Work Order ID 140886

Item Name: E4702-041 Ladder Modification

Eagle Service Instruction Number: **ESI 9739**

Description: **E4702-041 Ladder Modification**

FIGURE 1 - D4702-041 LADDER MODIFICATION
(SERVO ATTACHMENT BOLTS REMOVED FOR CLARITY)

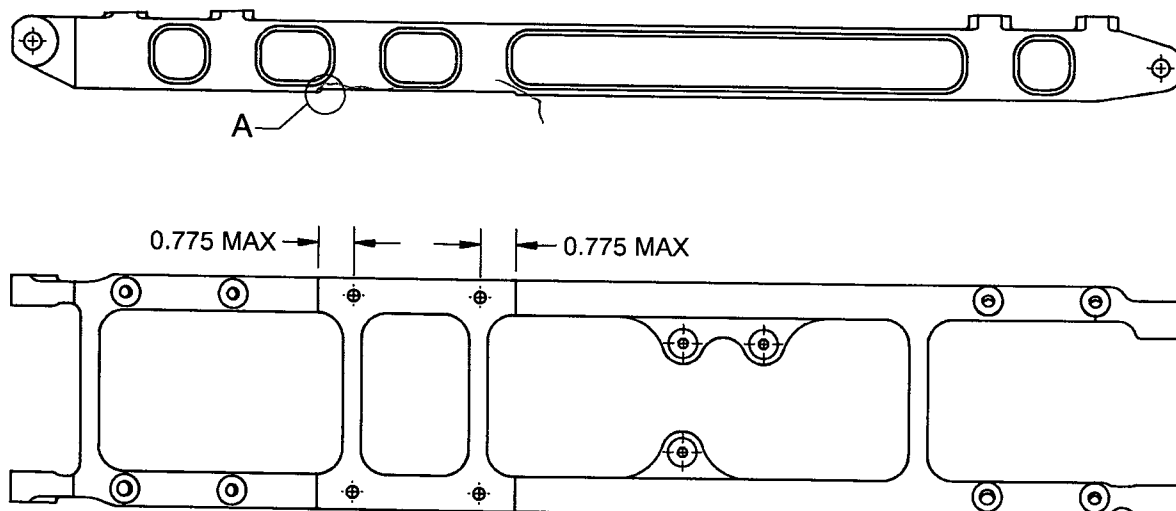
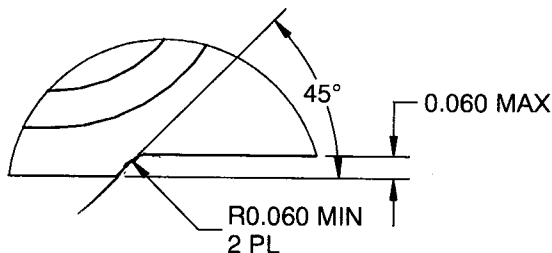
During the installation of the E205-828 Dual Hydraulic Collective Control System, it has been discovered that certain existing aircraft vary with respect to the location (height) of the lift beam. This variation may cause the holes at either end of the E4702-041 Ladder Assembly to be mis-aligned with their attachment holes. This ESI give instructions for the removal of material in order to achieve alignment of the attachment holes.

1. Remove material from the bottom of the E4702-041 Ladder Assembly in the area of the lift beam attachment for the purposes of achieving alignment of the Ladder Assembly attachment holes to a maximum of 0.060". See Figure 1 for details.
2. Touch up machined surface with Alodine 1200/1201 per MIL-C-5541 and prime per aircraft Maintenance Manual

FIGURE 1 - D4702-041 LADDER MODIFICATION
(SERVO ATTACHMENT BOLTS REMOVED FOR CLARITY)

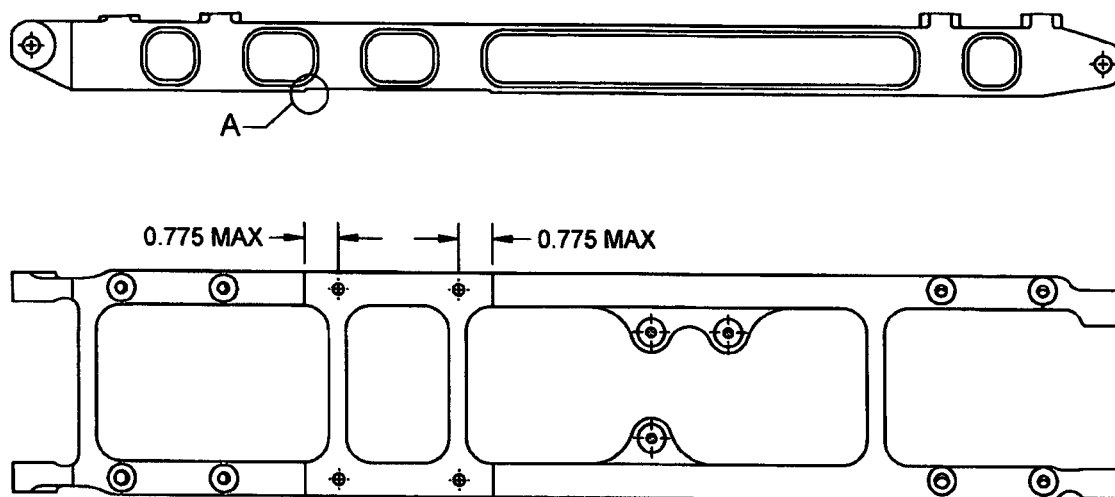
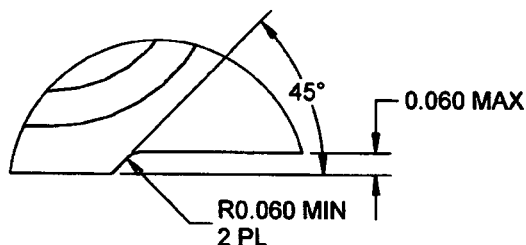
During the installation of the E205-828-011 Dual Hydraulic Collective Control System, it has been discovered that some aircraft may vary with respect to the location (height) of the lift beam. This variation may cause the holes at either end of the E4702-041 Ladder Assembly to be mis-aligned with their attachment holes. This ESI give instructions for the removal of material in order to achieve alignment of the attachment holes.

1. Remove material from the bottom of the E4702-041 Ladder Assembly in the area of the lift beam attachment for the purposes of achieving alignment of the Ladder Assembly attachment holes to a maximum of 0.060". See Figure 1 for details.

Note: Surface finish after machining must be no greater than 80 microinch

2. Liquid Penetrant Inspect part after machining per ASTM 1417 Level 2
3. Touch up machined surface with Alodine 1200/1201 per MIL-C-5541 and prime per aircraft Maintenance Manual
